## 64STAFF REPORT COMMUNITY DEVELOPMENT DEPARTMENT

HEARING DATE: 12/15/2020  
TO: Mayor & City Council  
FROM: Alan Tiefenbach, Associate Planner  
208-489-0573  
SUBJECT: H 2020-0010  
Brody Square Final Plat  
LOCATION: The site is located within the northeast quadrant of N. Black Cat Road and W. McMillan Road., in the SW ¼ of Section 27, Township 4 N., Range 1W.

Final plat consisting of 64 buildable lots, and 9 common lots on 14.5 acres of land in the R-8 zoning district developing in a single phase.

B. Final Plat (date: 9/9/2020)

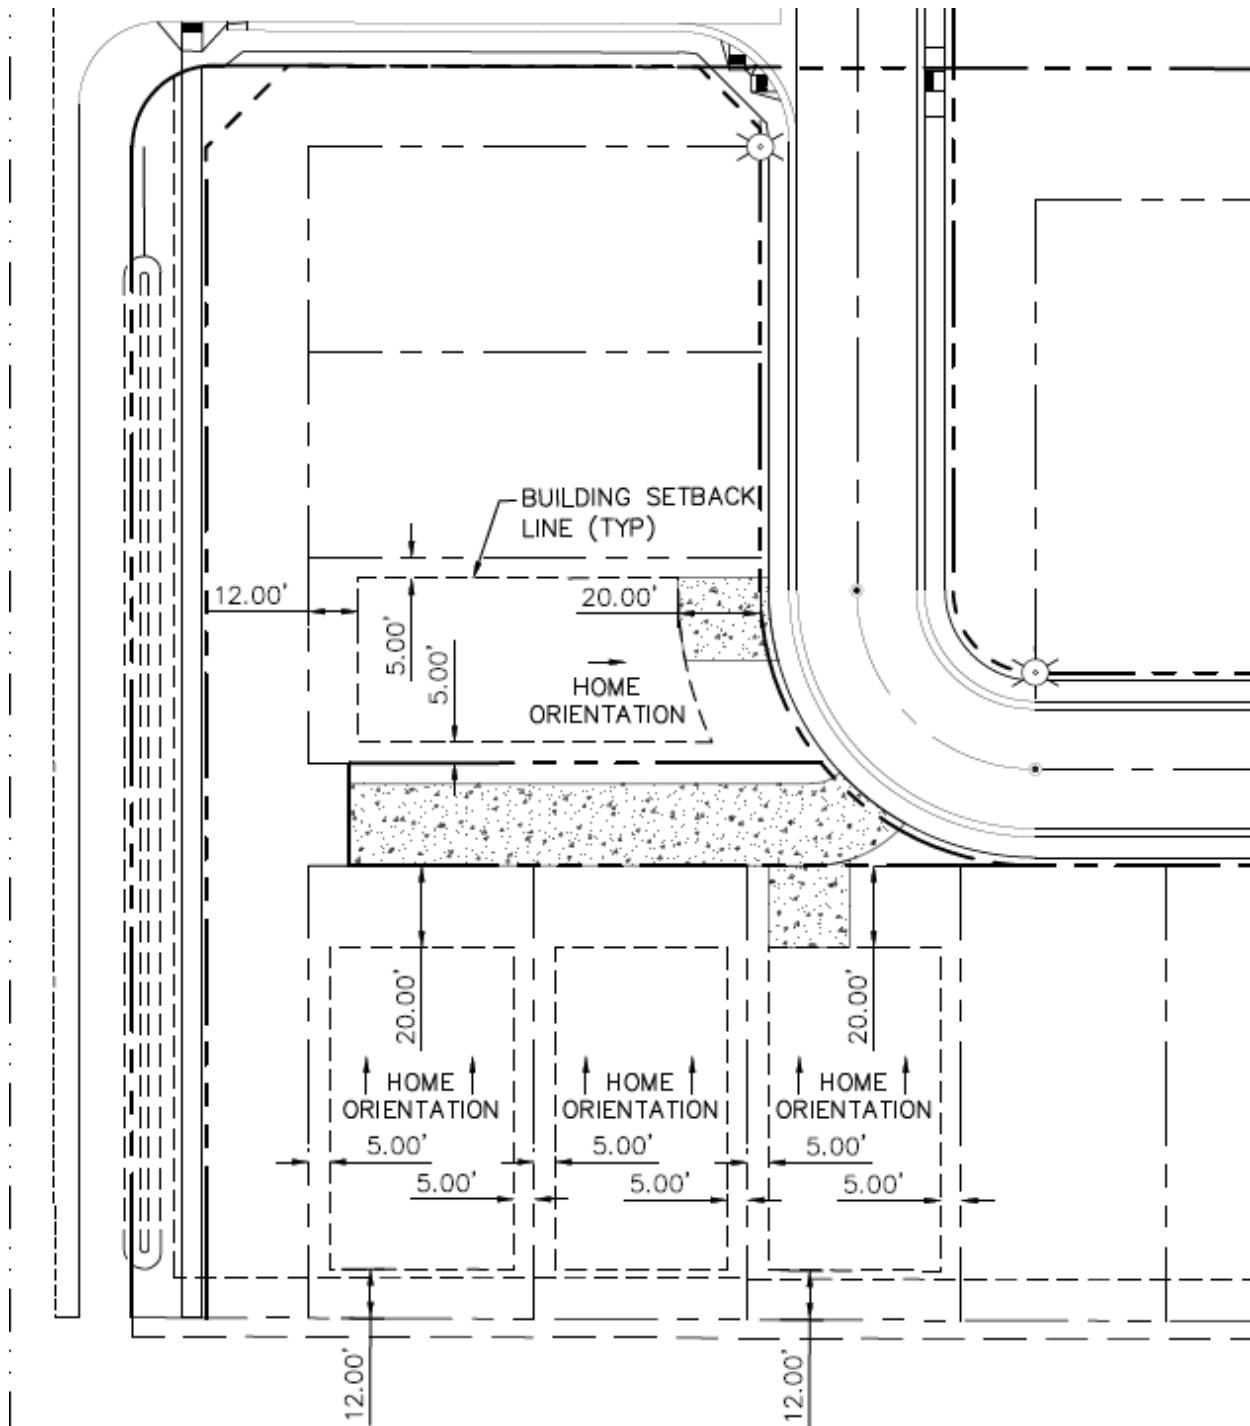
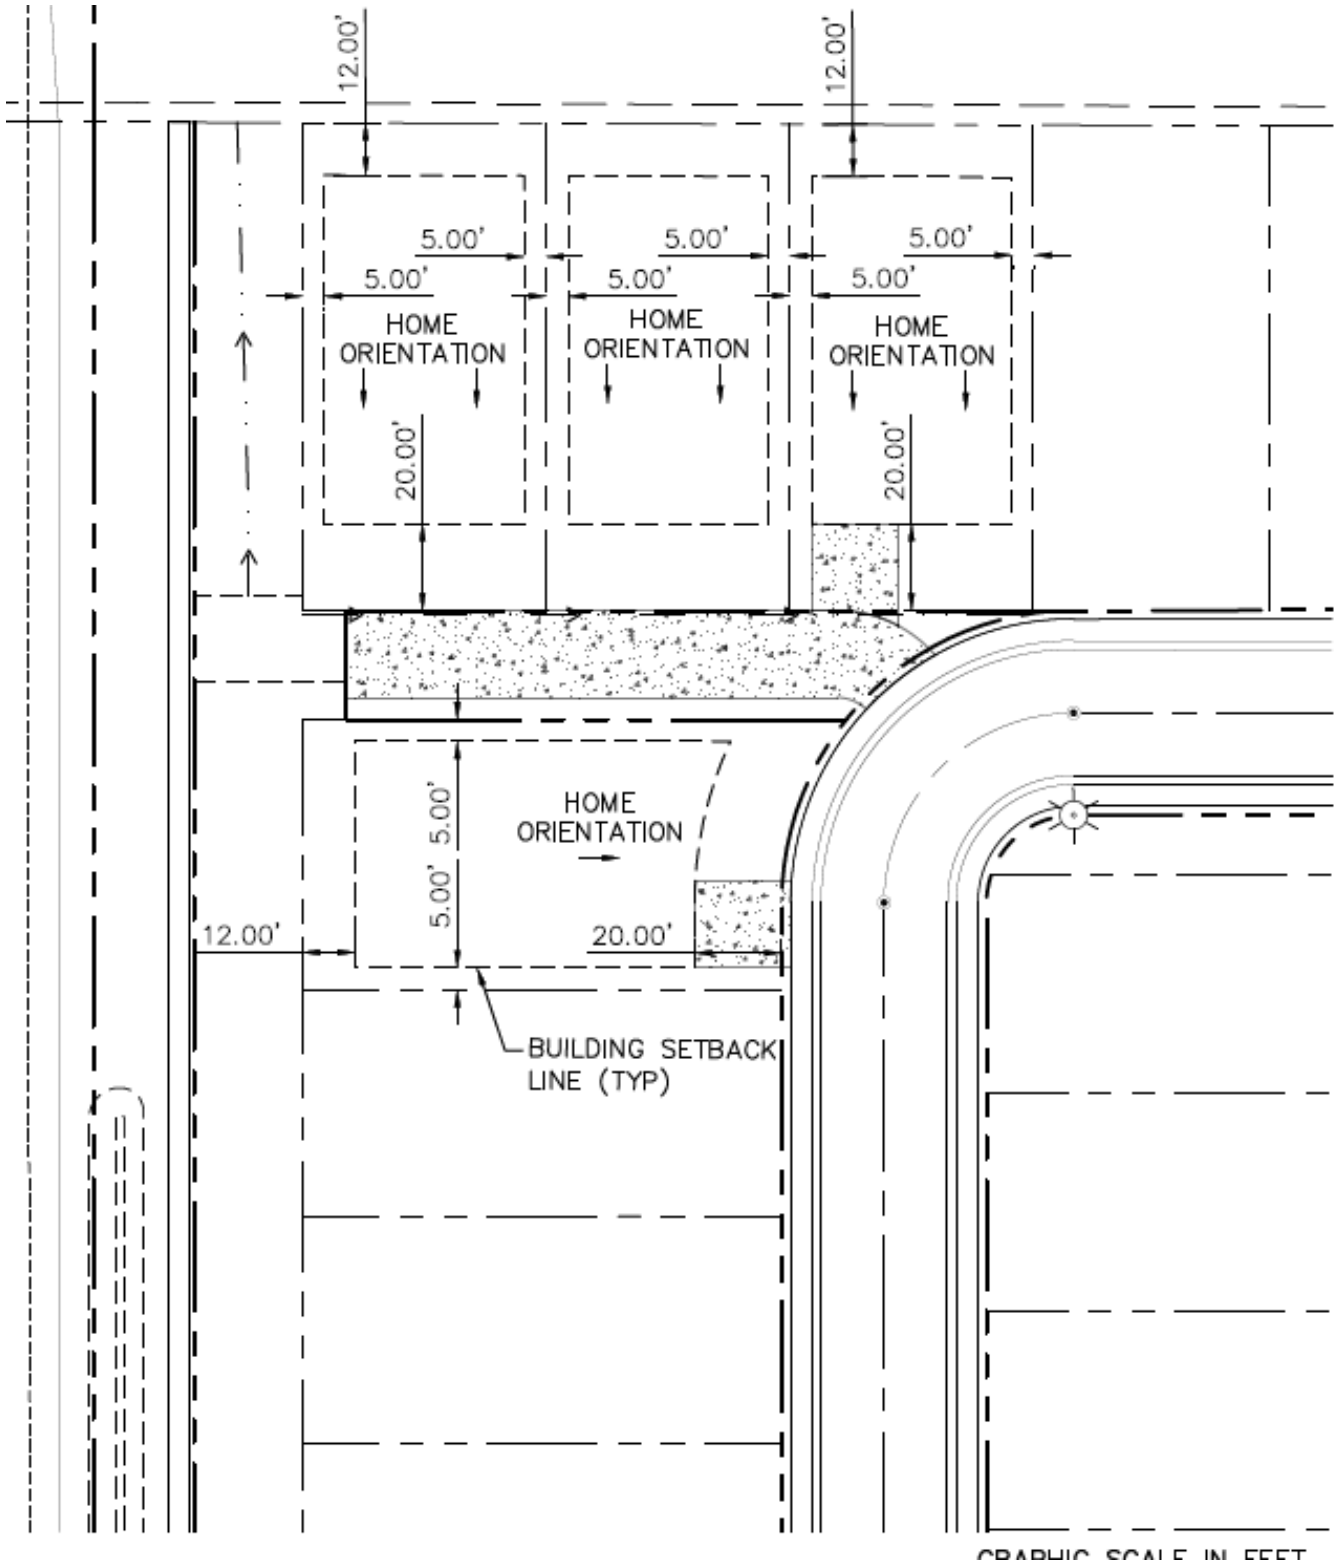
3. Prior to City Engineer signature on the final plat, the applicant shall provide documentation that ACHD has approved the vacation of Daphne St.
4. Prior to City Engineer signature on the final plat, the final plat prepared by Land Solutions, LLP, stamped by Clinton W. Hansen, dated: 9/9/2020, included in Section V.B shall be revised as follows:

- a. Add a note which restricts homes on Lots 8-10, Block 1 to one-story.
  - b. Note 2: Add dimensions to easement language. (5-feet each side required, and 10-feet to the the rear)

- c. Note 10: Add Development Agreement Instrument Number 2020-138110.
  - d. Note 12: Add ACHD License Agreement Instrument Number.
5. Prior to the City Engineer signature on the final plat, the landscape plan, prepared by Kimley Horn, dated 10/12/2020, included in Section V.D shall be revised to include a mitigation plan approved by the City Arborist which indicates the total number and caliper inches of trees proposed for removal and the total number of replacement trees proposed.
